Access Compliance Report

Public Rights-of-Way

(Curb Ramps)

Intersection ID: 25066	Main Street: BIRNEN_DR	Cross Street: PARK_RD	Location: NW
ADA ID: 6615E200DB66	Ramp Type: PerpDiag	Initial Pass/Fail: Fail	Overall Compliance: No
		Severity Score: 12.5

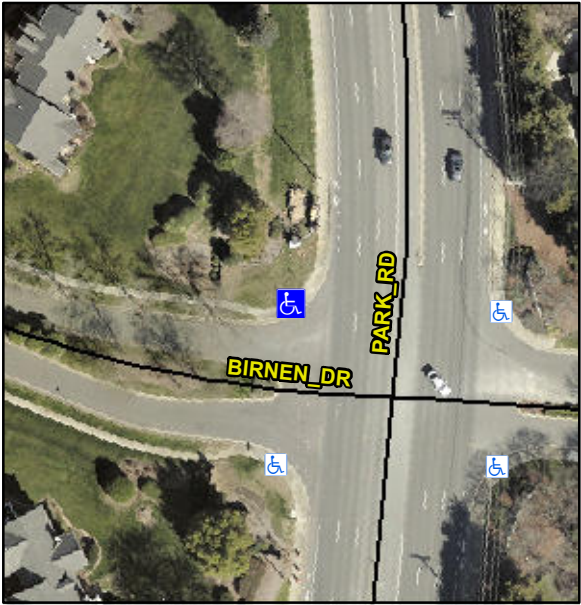
Codes/Mitigation Info/Possible Solution			Field Measurements/Component Compliance		
	Possible Solutions:		Compliance	Description	Data
	Remove & Replace Curb Ramp With Two New Directional Ramps or Equivalent.		No	Ramp Length (in)	60.0
			Yes	Ramp Width (in)	48.0
			N/A	Flare Type LT	N/A
			N/A	Flare Slope LT (%)	N/A
			N/A	Flare Traversable LT?	N/A
			N/A	Landing Length (in)	N/A
			N/A	Landing Width (in)	N/A
			N/A	Landing Slope (%)	N/A
			N/A	Landing X Slope (%)	N/A
			N/A	Landing Curb? (Y/N)	N/A
			N/A	Shared Landing?	N/A
			N/A	Gutter Ponding?	N/A
			N/A	Gutter Lip Ht (in)	N/A
			No	Painted X Walk1?	N/A
				X Walk 1 Direction	To SW
			N/A	X Walk 1 Width (in)	N/A
				X Walk 1 Slope (%)	0.9
				X Walk 1 X Slope (%)	0.7
			N/A	Ramp inside XWalk1?	N/A
Surveyor Notes: N/A PROW/ADA: Not Found, R304.2.2			N/A	Ramp inside XWalk2?	N/A
				Road Slope (%)	0.0
				Road X Slope (%)	1.2
			N/A	Any Obstructions?	N/A
				Obstruction Type
